Exh. AES000001

AES RESPONSES TO PUBLIC SAFETY QUESTIONS

FIGURE 1
Topography Around EREF

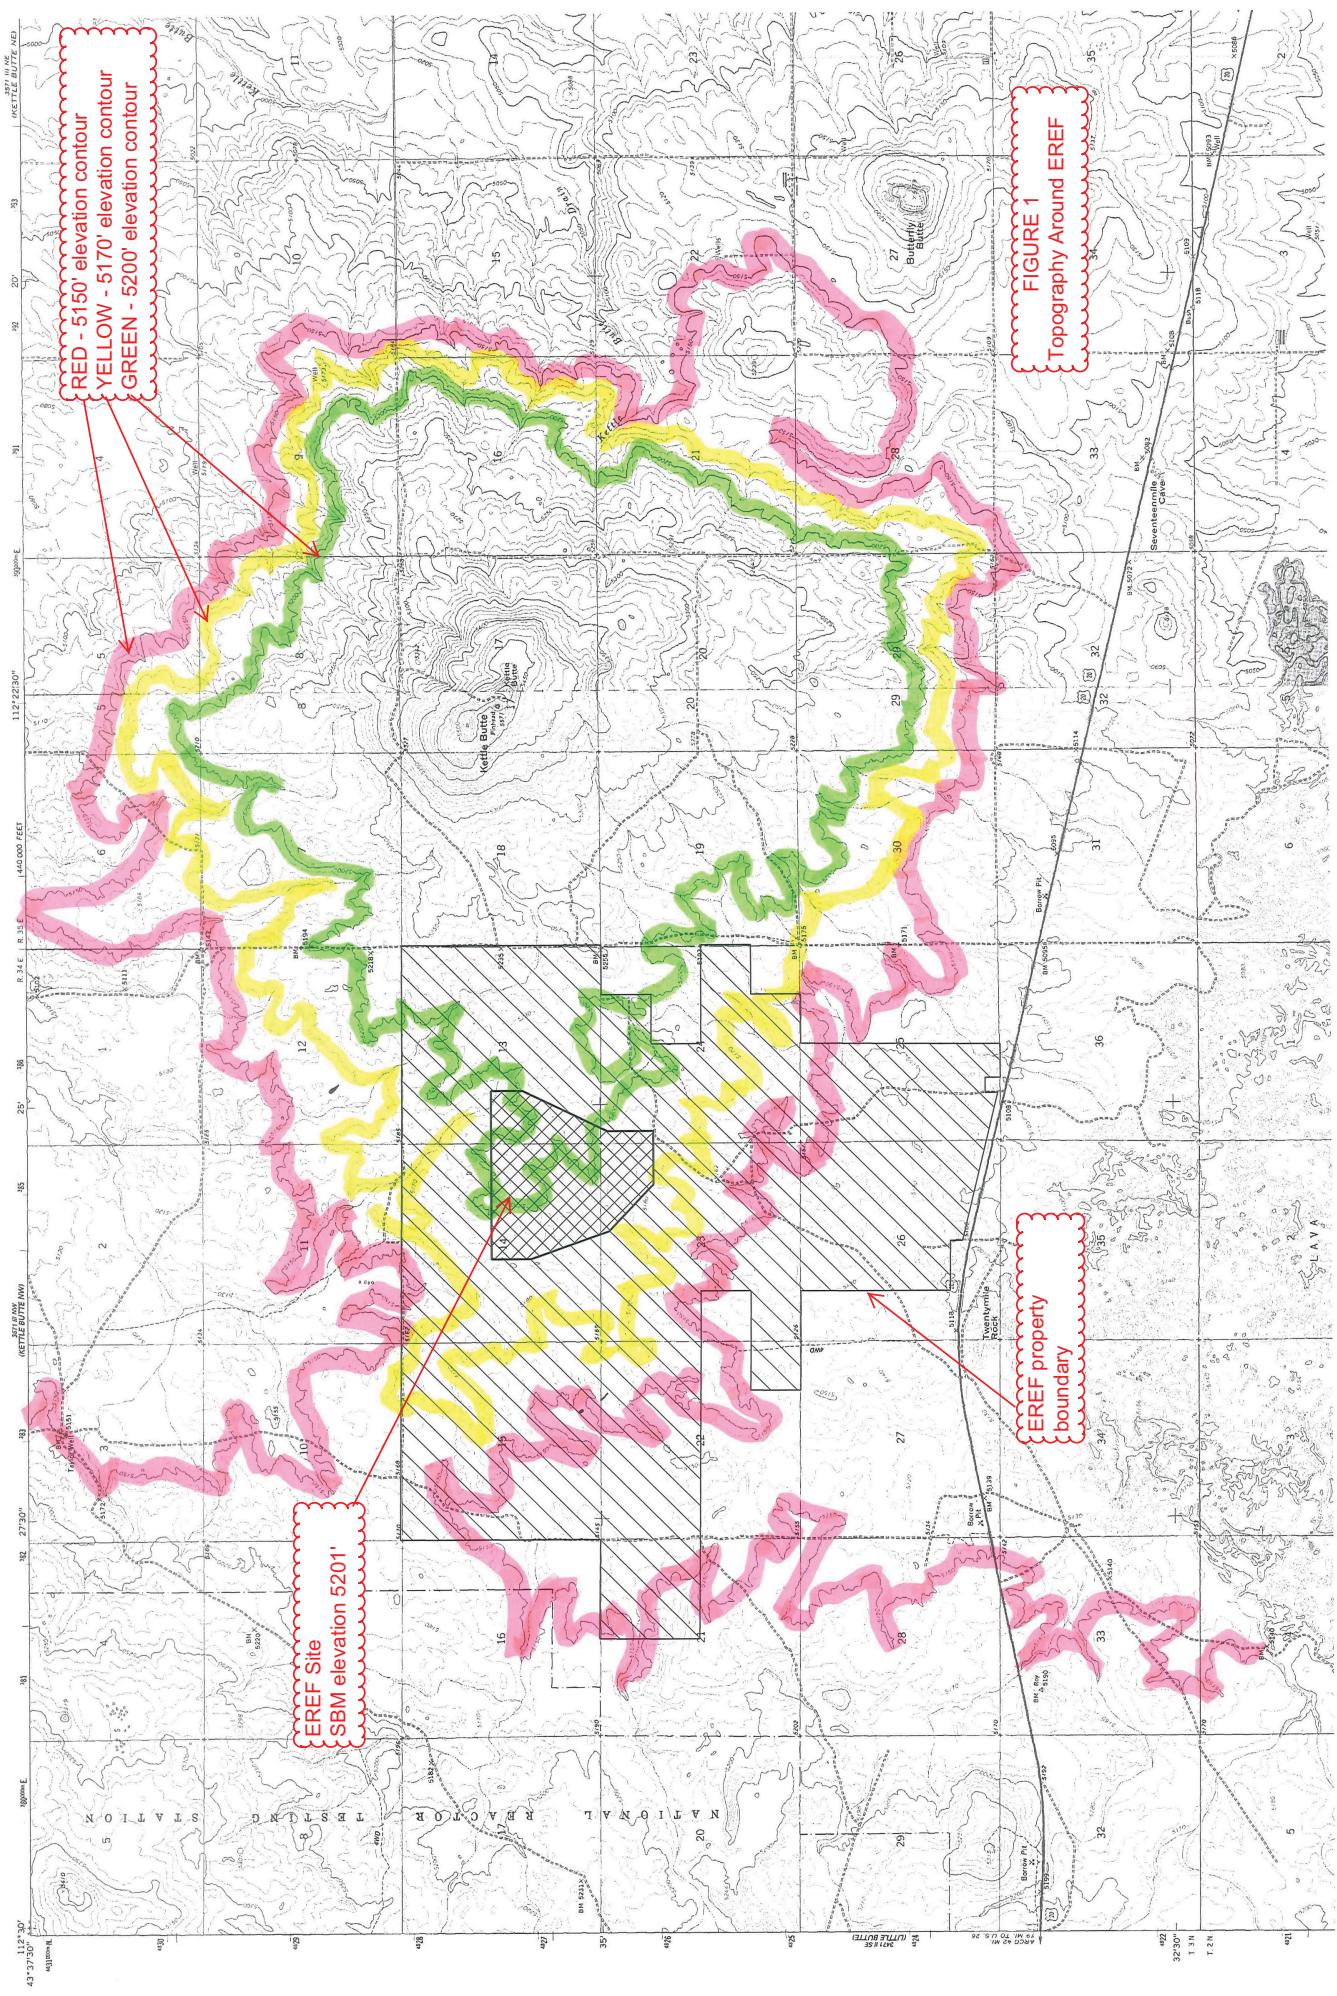
(once it has been determined that lava is headed toward the facility). Such berms could be constructed of rock and soil excavated from the nearby land surface. Blong (1984, p. 193) (Exh. AES000046) reports numerous observations showing that lava flows with low yield strengths (*i.e.*, basaltic pahoehoe flows) can be diverted by resistant structures, if properly constructed. Additional mitigation measures would also include placing the facility in a safe mode and consolidating storage areas for material that could be released. Figure 1 (attached) also shows that the topography around the EREF is beneficial and provides substantial natural barriers to inundation at the site. With the site elevation at 5201 feet, the terrain would divert lava flows of up to 8-10 m thick. The PVHA does not explicitly account for this topographical protection or take credit for its effects.
